ADDENDATOTHE RDF-10 RADIO DIRECTION FINDER

The following corrections and changes should be applied to the current issue of the RDF-10 Radio Direction Finder Instruction Manual.

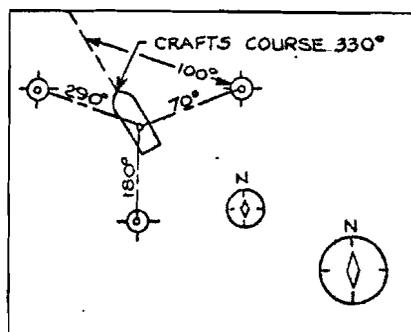
1. Page 7, Calibration, Item 9 should be as follows:
  9. Plot the 36 readings taken on the deviation chart, figure 5.

For example the readings may appear as follows:

The curve for these example readings are shown as a dotted line on the deviation chart.
